ONS-2015-055

Duke Energy Carolinas, LLC (Duke Energy)  
Oconee Nuclear Station, Units 1, 2 and 3  
Docket Numbers 50-269, 50-270, 50-287  
Renewed License Numbers DPR-38, DPR-47, and DPR-55

**Subject:** Second Response to Request for Additional Information dated October 23, 2014,  
Related to Southeastern Catalog Changes and Seismic Re-Evaluations

Oconee Nuclear Station Units 1, 2, and 3, Duke Energy Response to RAI:  
Senior Seismic Hazard Analysis Committee (SSHAC) Level 2 Study

**Figure 16: Seismicity with  $E[M] \geq 2.9$  occurred within 100 km of the Oconee NPP from 1968 through December 2007: a) from Rev 7 of the CEUS-SSC earthquake catalog; b) from Rev 8.**

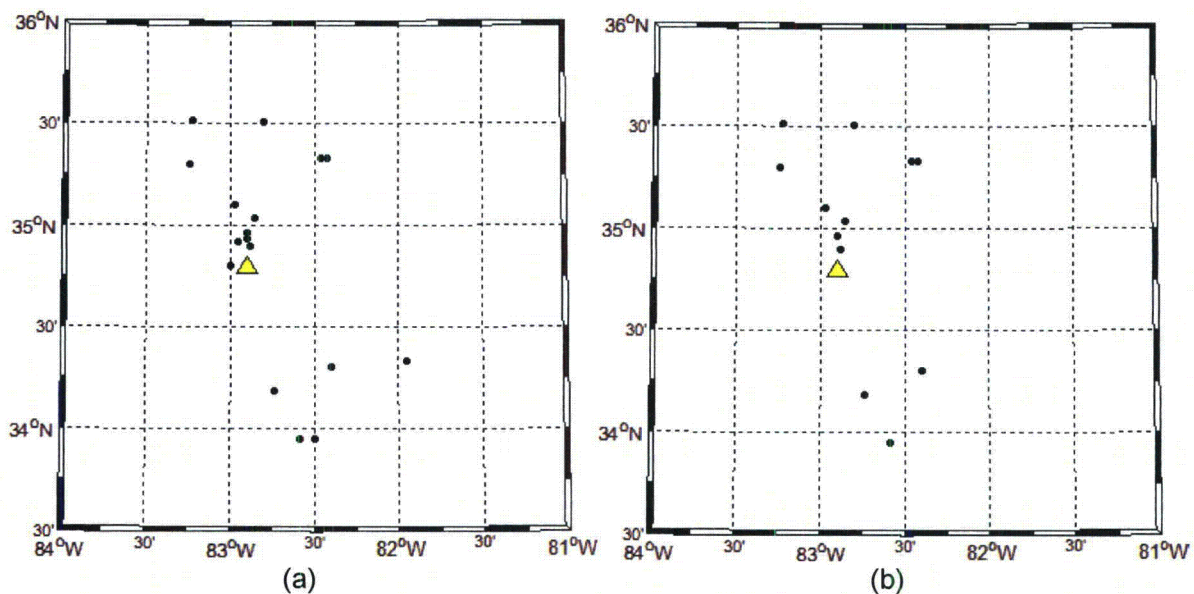
Comment Number	Reference	Description	Response
23	Section "Additional RIS Earthquakes/ Summary"	Consider providing a summary figure that shows the seismicity from the CEUS SSC catalog Version 7 for the SEUS and identifies (e.g., filled versus open symbols) the 30 events now being moved to the nontectonic events catalog. It would also be useful to discriminate those newly classified RIS events that have E[M] of 2.9 or greater and thus would impact recurrence calculations. Multiple figures might be needed to show the information at a useful scale.	Added figures 16 and 17.
24	Section "Development of a Version 8 Catalog"/ "Revised Assignments of Parameters"	First sentence: The previous section states that seven earthquakes are identified as possibly mis-located. Here the assessments of six earthquakes are mentioned. Seven were assessed, but one was not changed. This apparent difference (seven versus six) should be clarified to avoid confusion.	Text revised for clarity.
